1st Further Information

**Proposed Temporary Warehouse (Excluding Dangerous Goods Godown) with Ancillary Facilities
for a Period of 3 Years in "Recreation" Zone, Various Lots in D.D. 78 and Adjoining
Government Land, Lin Ma Hang, Ta Kwu Ling North, New Territories**

(S.16 Planning Application No. A/NE-TKLN/86)

Responses-to-Comments

Project No. 83018	Rev.
Dwg No. Figure B	-

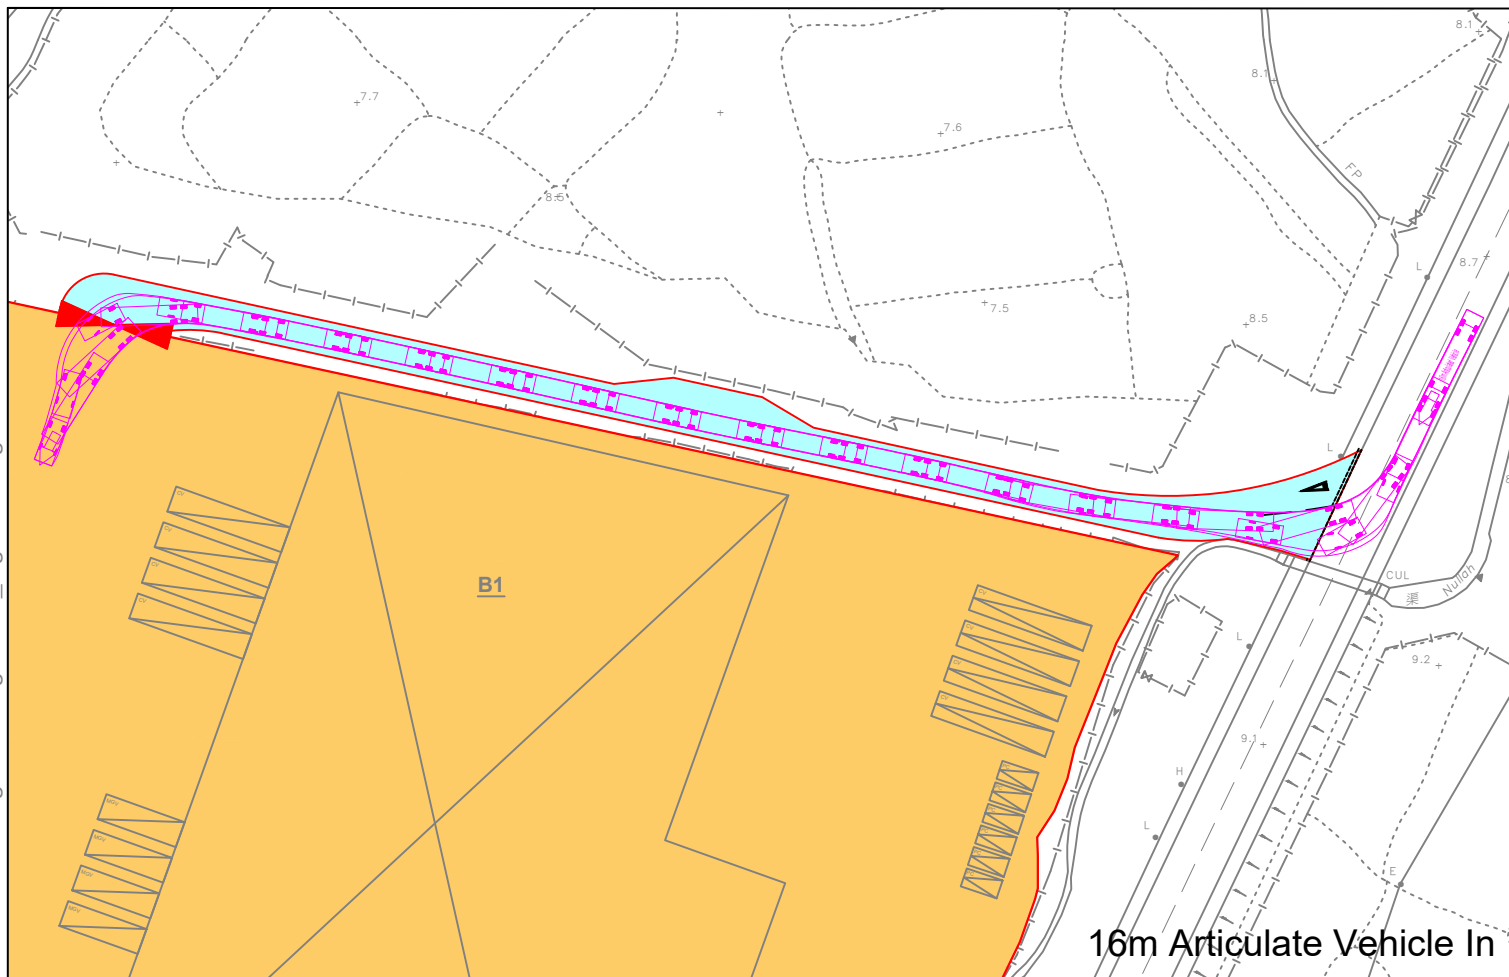
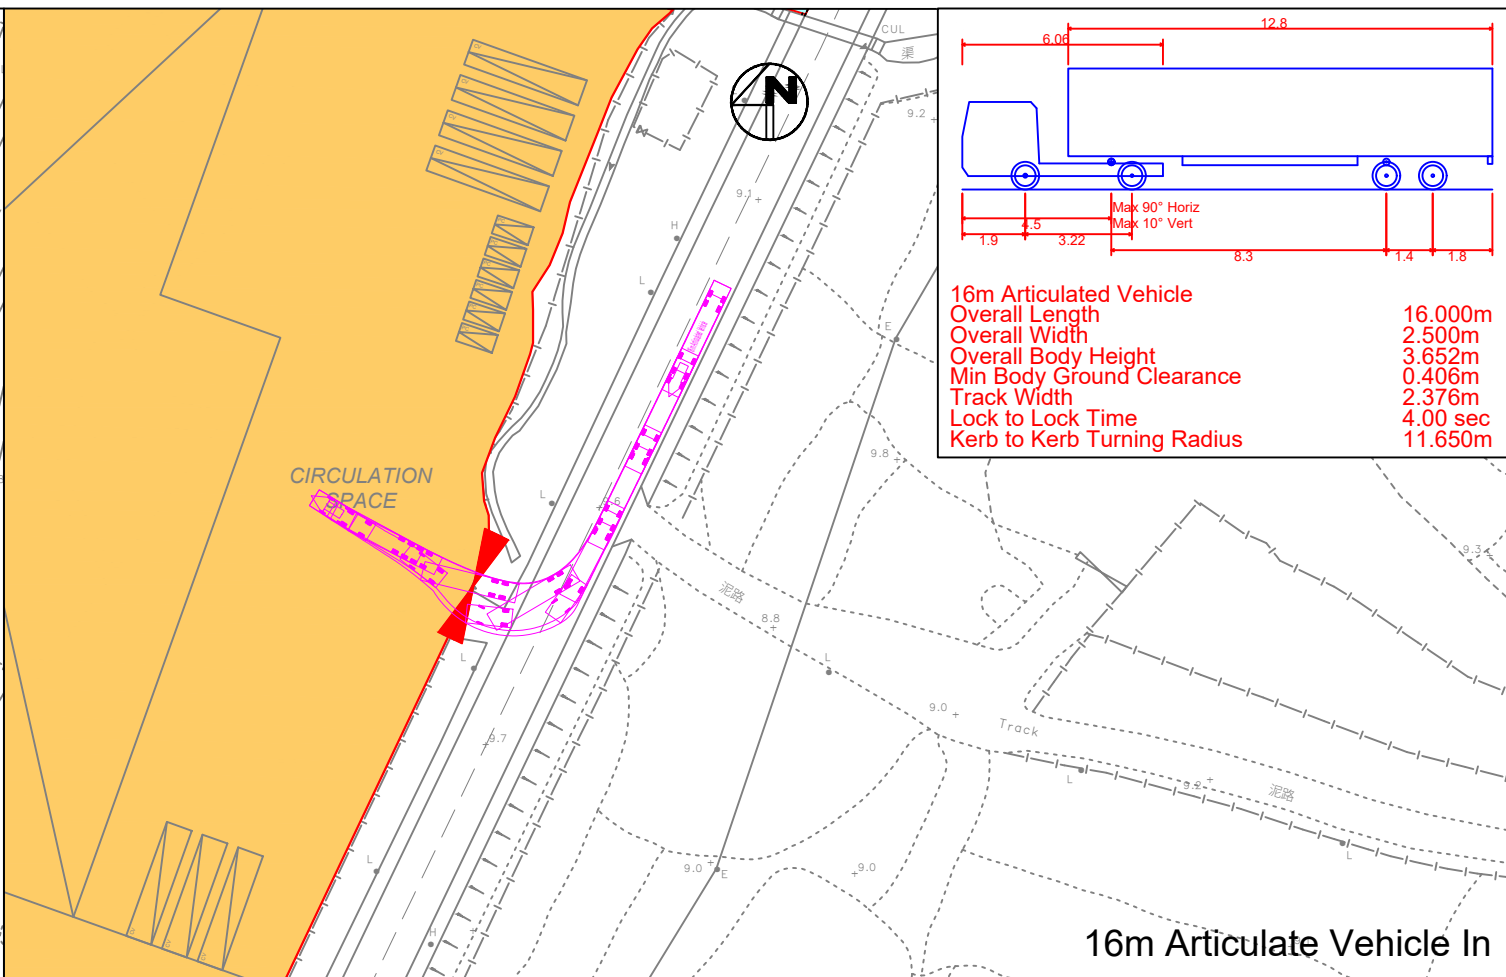
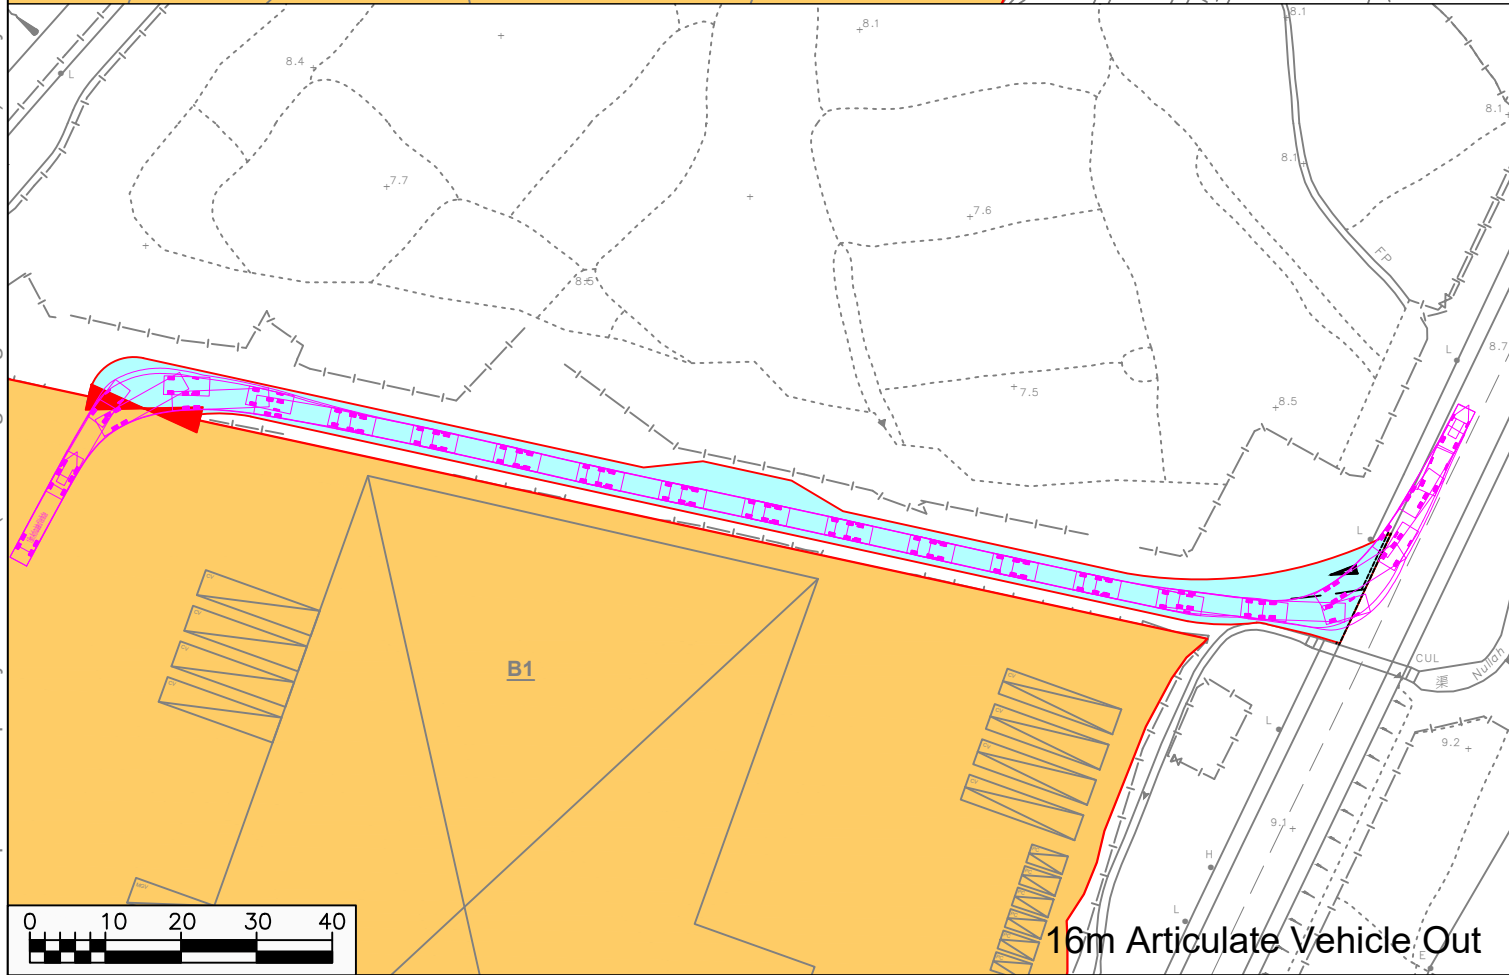
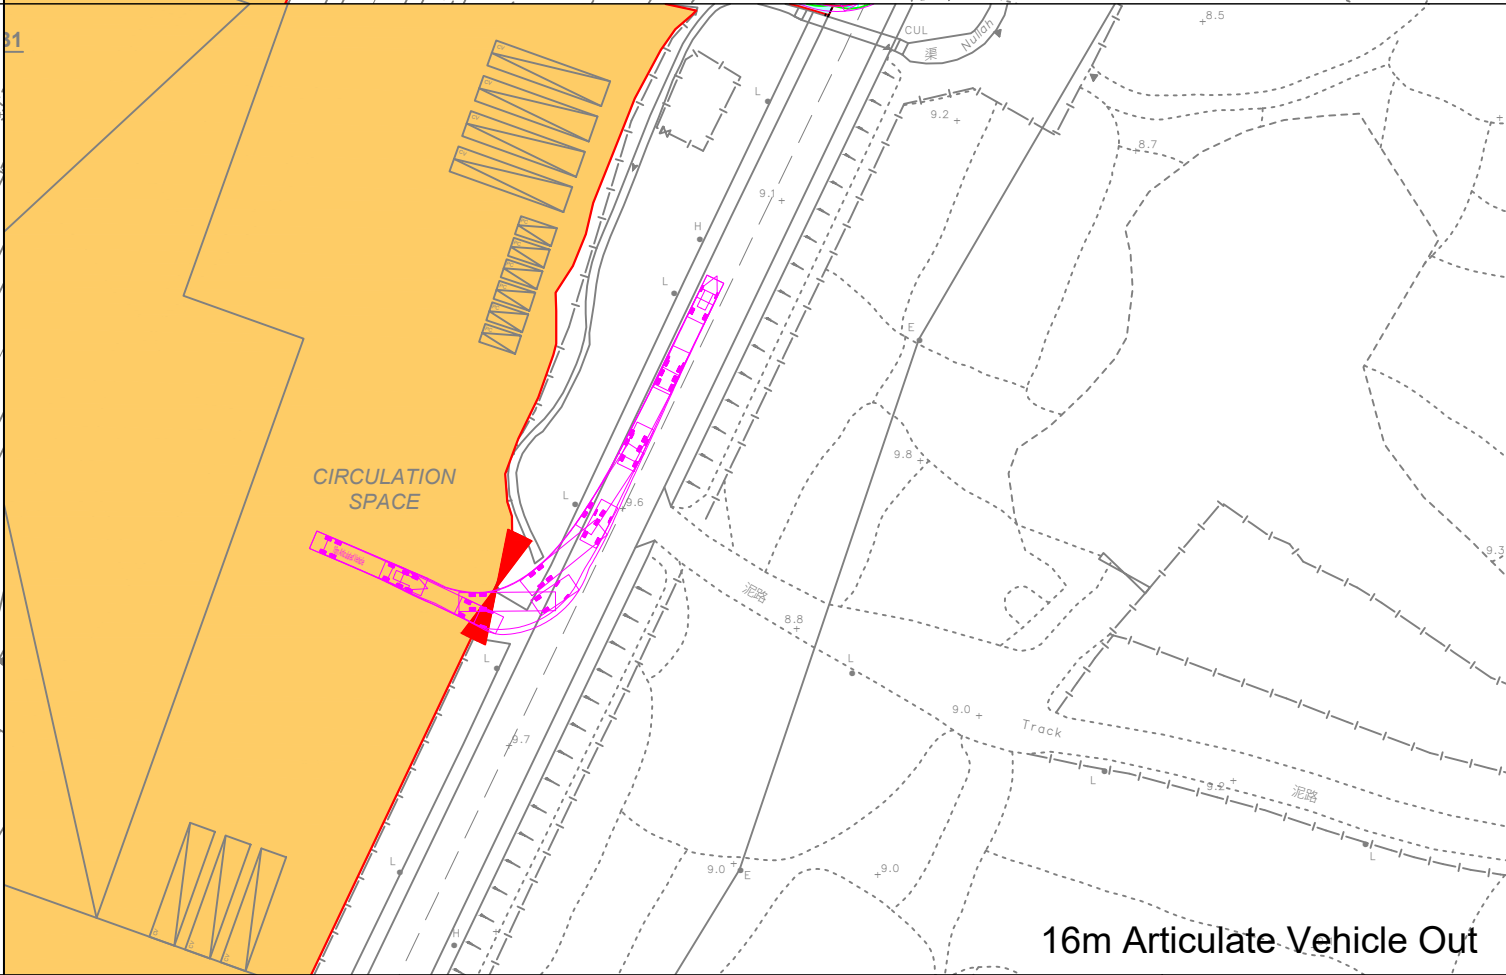
(b)	The applicant shall demonstrate the satisfactory manoeuvring of the goods vehicles entering and exiting the subject site, it seems that left turns of long vehicles entering/leaving the site need to encroach onto the opposite lane.	The swept path analysis at Appendix A of the Traffic Impact Assessment (TIA) report (Annex 3) has been revised to avoid left turns of long vehicles encroaching onto the opposite lane when entering/leaving the Site.

DWG. TITLE LAND STATUS OF THE SITE	
DWG. NO. PLAN 3	VER. 001

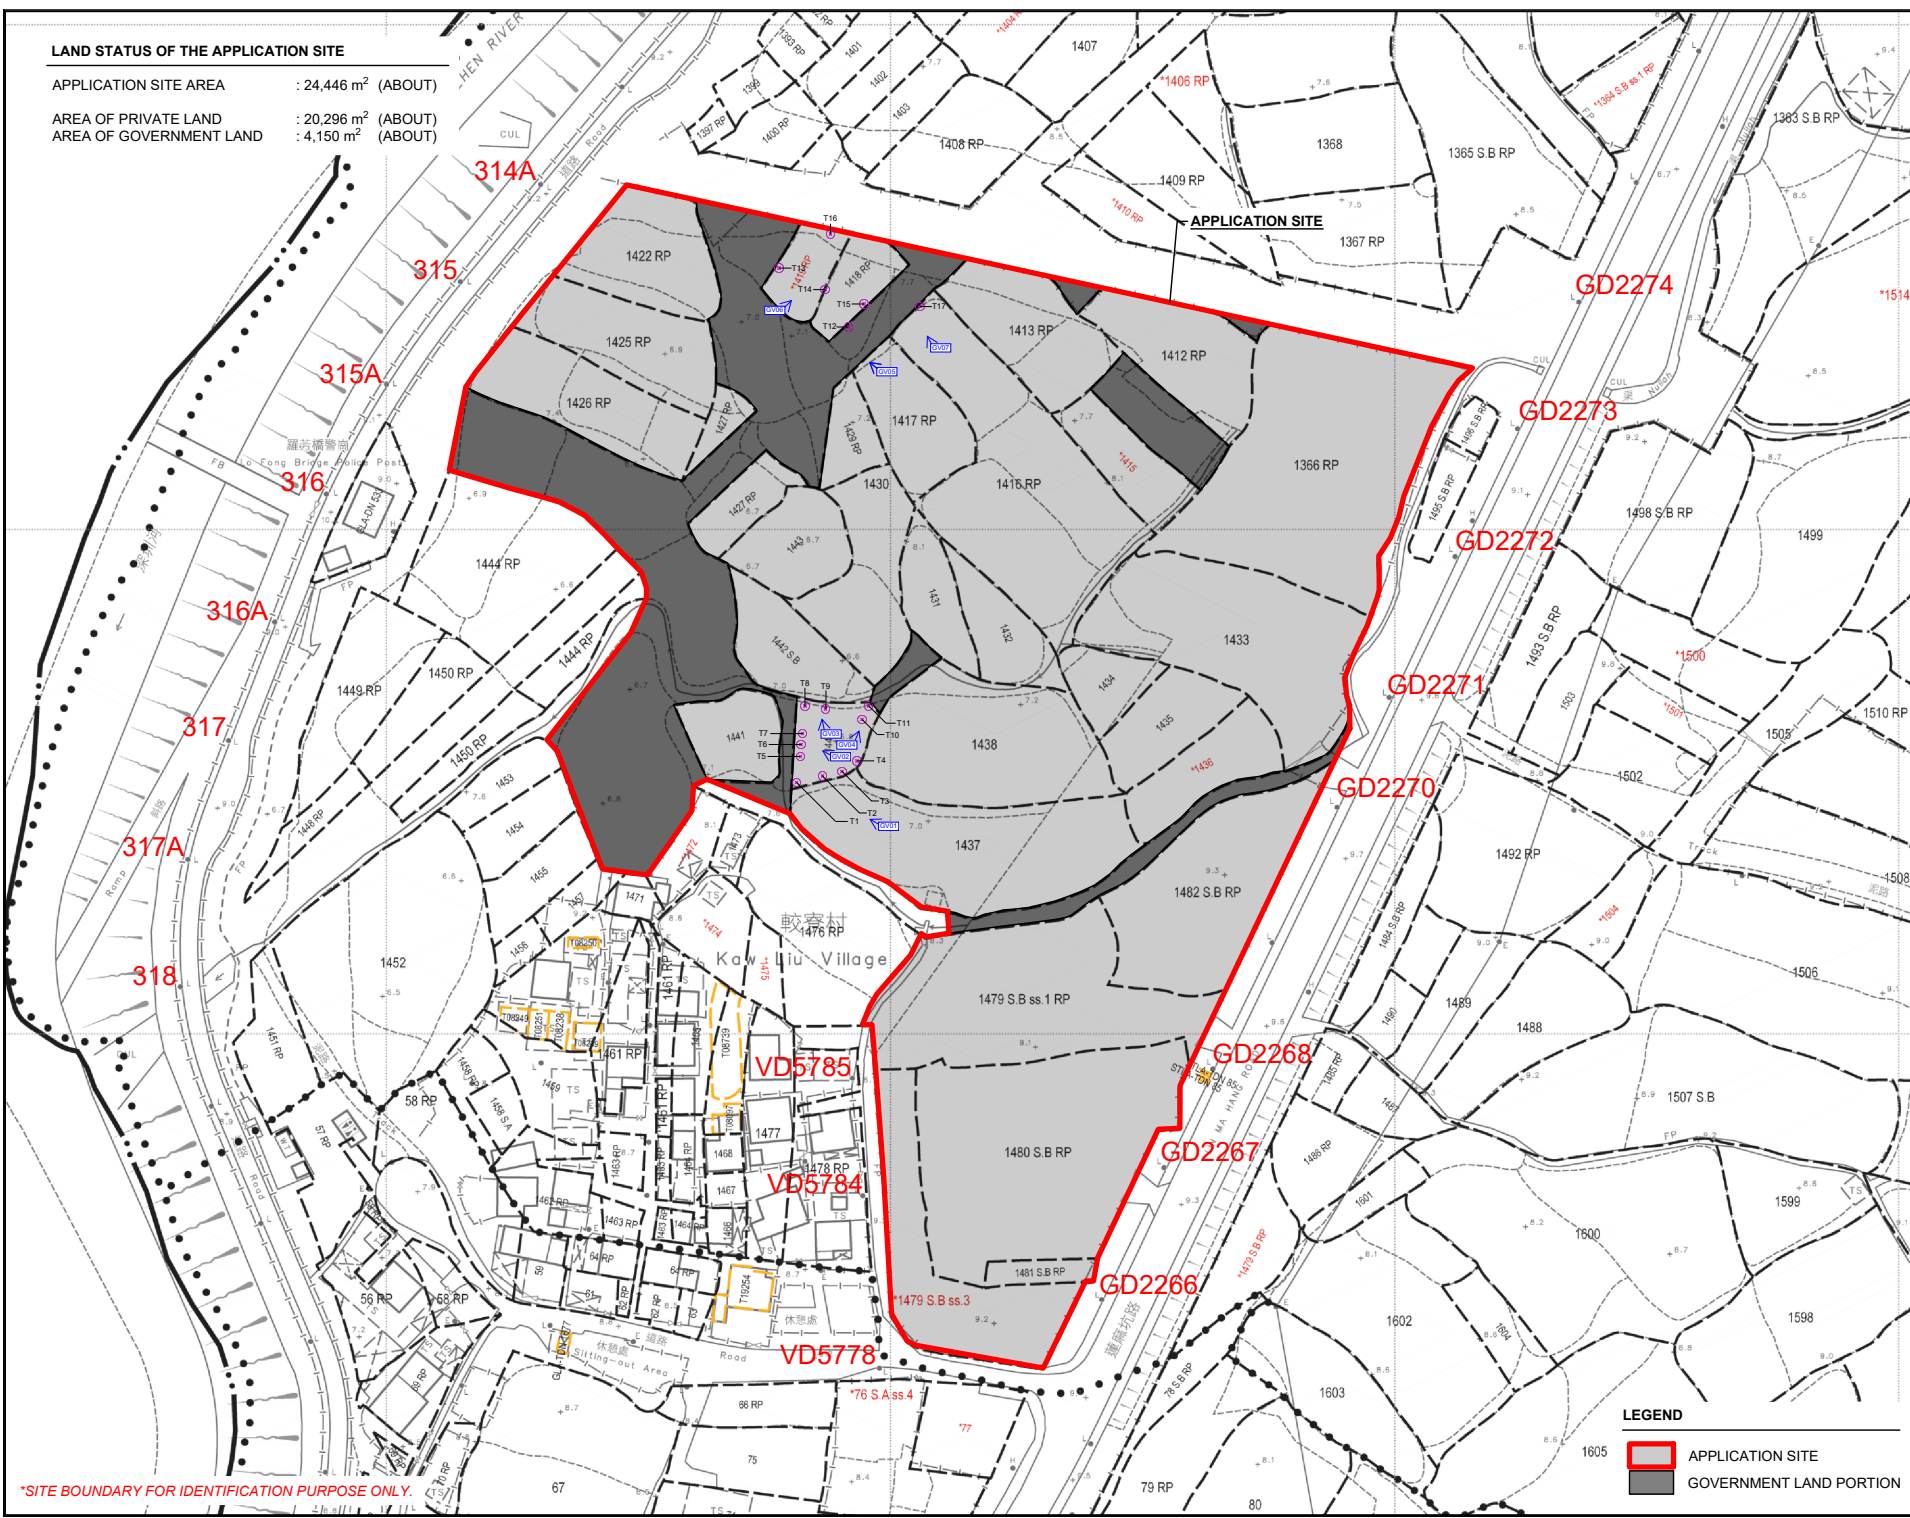
<p>(b)</p>	<p>The applicant is advised to provide broad-brush survey with basic information (e.g. numbers, species, size, general conditions and tree photos) on existing trees within and along the site boundary, proposed tree treatment and proposed mitigation measures, if any, for TPB’s consideration.</p>
<p>(c)</p>	<p>The applicant should be advised that approval of the application does not imply approval of tree works such as pruning, transplanting and felling. The applicant is reminded to seek approval for any</p>
